Subject: **Request for Permit Modification of Section 404 Permit and Section 401 Water Quality Certification** for the proposed new interchange on I-26 (future exit 35) and roadway extension, Buncombe County, Division 13. WBS No. 49472.1.2, **TIP: HE-0001**

Reference: (1) Section 404 Individual Permit, Action ID No. SAW-2021-0535, issued August 11, 2023;
(2) Section 401 Water Quality Certification No. 005958, NCDWR Project No. 20230518, issued June 15, 2023.

**PERMIT DRAWING
SHEET 1 OF 5**

WETLAND AND SURFACE WATER IMPACTS PERMIT

**PERMIT DRAWING
SHEET 3 OF 5**

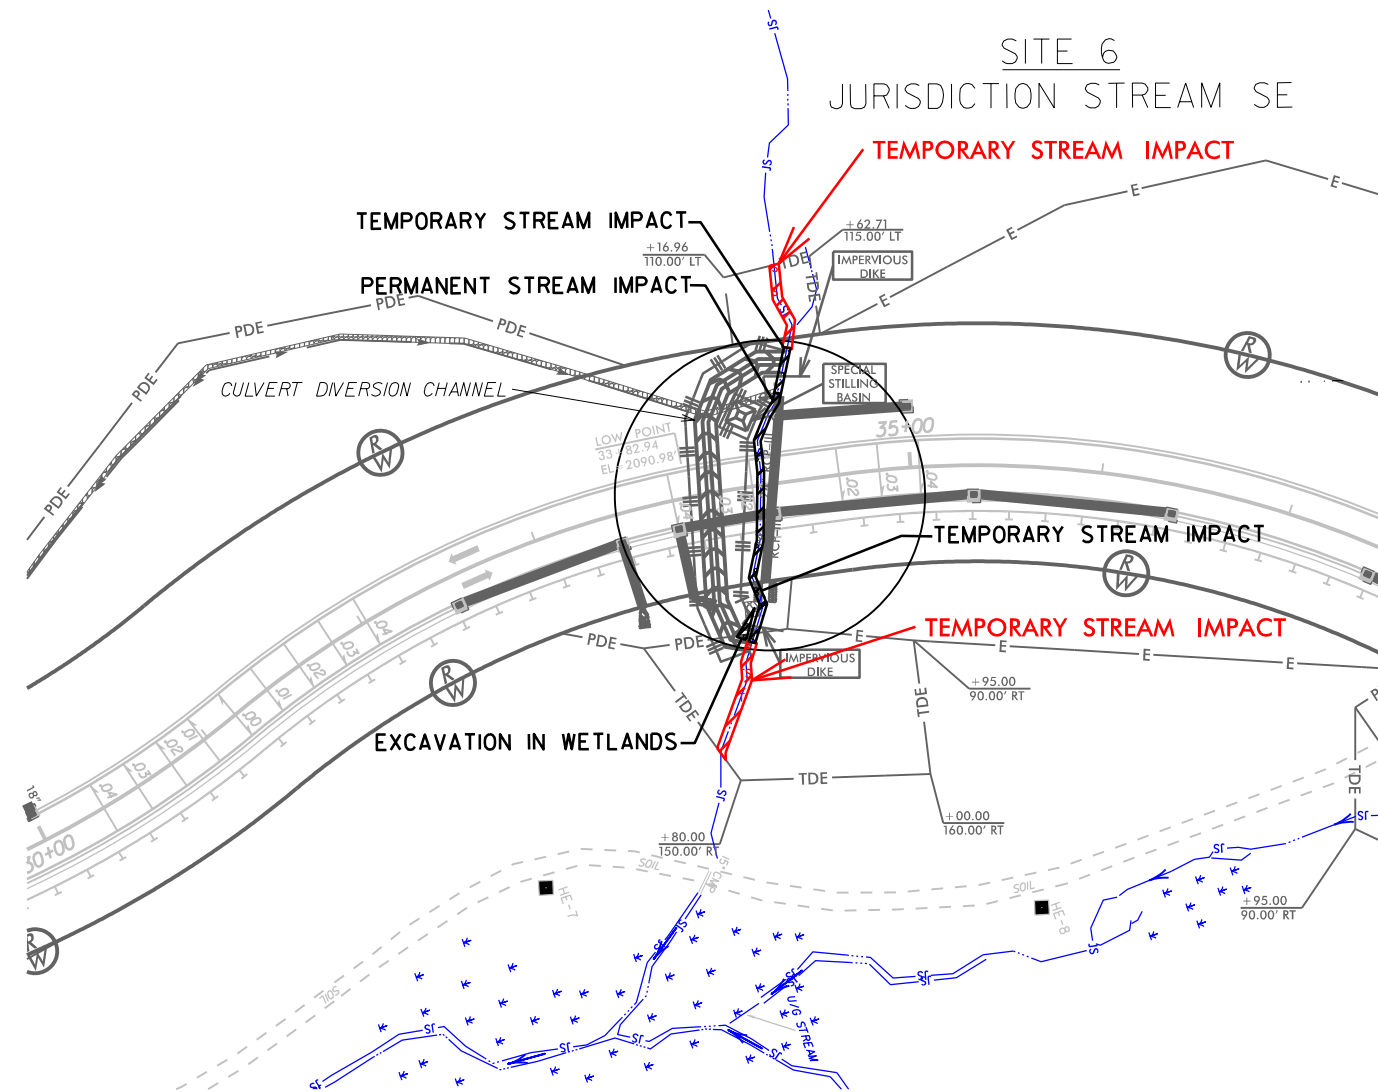
Site 6

The original design included 45 linear feet of temporary stream channel impact to stream SE resulting from proposed impervious dikes associated with the stream channel dewatering. The construction plan design for a culvert diversion channel for necessary stream channel dewatering results in an additional 107 linear feet of temporary stream channel impacts. These impacts are associated with aligning, connecting, and stabilizing stream channels to the proposed culvert diversion channels.

CULVERT CONSTRUCTION SEQUENCE STA. 34+50 -Y-

1. BEGIN CULVERT CONSTRUCTION PRIOR TO ROADWAY FILL.
2. UTILIZE SPECIAL STILLING BASIN(S) AS NEEDED.
3. CONSTRUCT CULVERT DIVERSION CHANNEL (3 FT BASE, 2.5 FT DEEP, 2:1 SIDE SLOPES). INSTALL IMPERVIOUS DIKE A FOR ONE SIDE OF THE CHANNEL.
4. INSTALL IMPERVIOUS DIKES B AND C, DIVERTING FLOW INTO TEMPORARY CHANNEL.
5. DEWATER WORK AREA, CONSTRUCT PROPOSED CULVERT AND INLET/OUTLET CHANNEL IMPROVEMENTS IN THE DRY.
6. REMOVE IMPERVIOUS DIKES B AND C, ALLOWING FLOW THROUGH NEWLY CONSTRUCTED CULVERT.
7. REMOVE IMPERVIOUS DIKE A AND CULVERT DIVERSION CHANNEL.
8. FINISH INLET/OUTLET IMPROVEMENTS.
9. REMOVE SPECIAL STILLING BASIN(S) AND COMPLETE ROADWAY.

PERMIT DRAWING
SHEET 4 OF 5

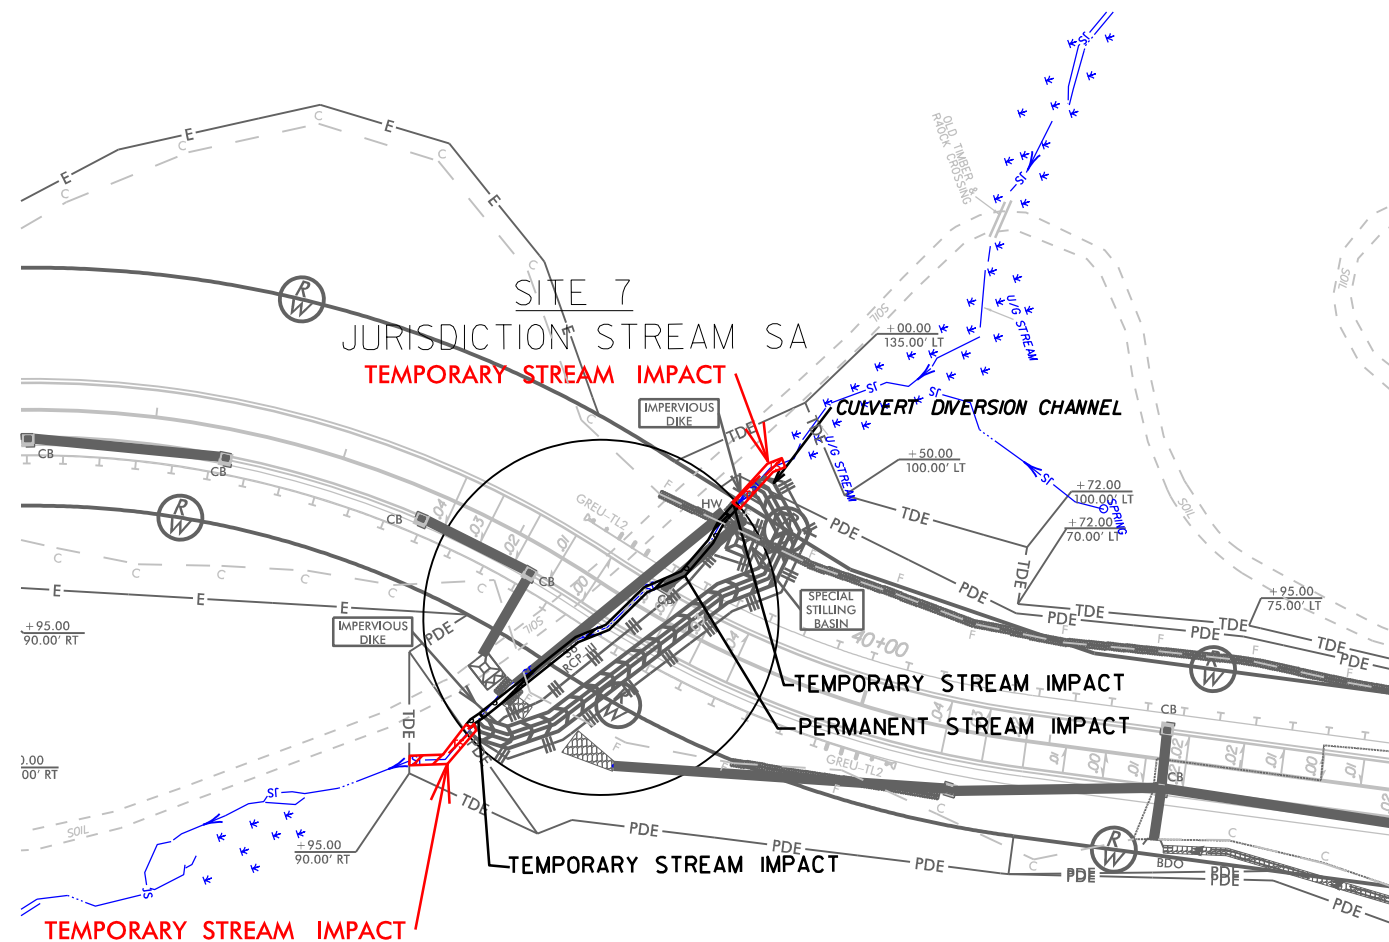
Site 7

The original design included 16 linear feet of temporary stream channel impact to stream SA resulting from proposed impervious dikes associated with the stream channel dewatering. The construction plan design for a culvert diversion channel for necessary stream channel dewatering results in an additional 76 linear feet of temporary stream channel impacts. These impacts are associated with aligning, connecting, and stabilizing stream channels to the proposed culvert diversion channels.

CULVERT CONSTRUCTION SEQUENCE STA. 39 + 00 -Y-

1. BEGIN CULVERT CONSTRUCTION PRIOR TO ROADWAY FILL.
2. UTILIZE SPECIAL STILLING BASIN(S) AS NEEDED.
3. CONSTRUCT CULVERT DIVERSION CHANNEL (3 FT BASE, 2.5 FT DEEP, 2:1 SIDE SLOPES). INSTALL IMPERVIOUS DIKE A FOR ONE SIDE OF THE CHANNEL.
4. INSTALL IMPERVIOUS DIKES B AND C, DIVERTING FLOW INTO THE TEMPORARY CHANNEL.
5. DEWATER WORK AREA, CONSTRUCT PROPOSED CULVERT AND INLET/OUTLET CHANNEL IMPROVEMENTS IN THE DRY.
6. REMOVE IMPERVIOUS DIKES B AND C, ALLOWING FLOW THROUGH NEWLY CONSTRUCTED CULVERT.
7. REMOVE IMPERVIOUS DIKE A AND CULVERT DIVERSION CHANNEL.
8. FINISH INLET/OUTLET IMPROVEMENTS.
9. REMOVE SPECIAL STILLING BASIN(S) AND COMPLETE ROADWAY.
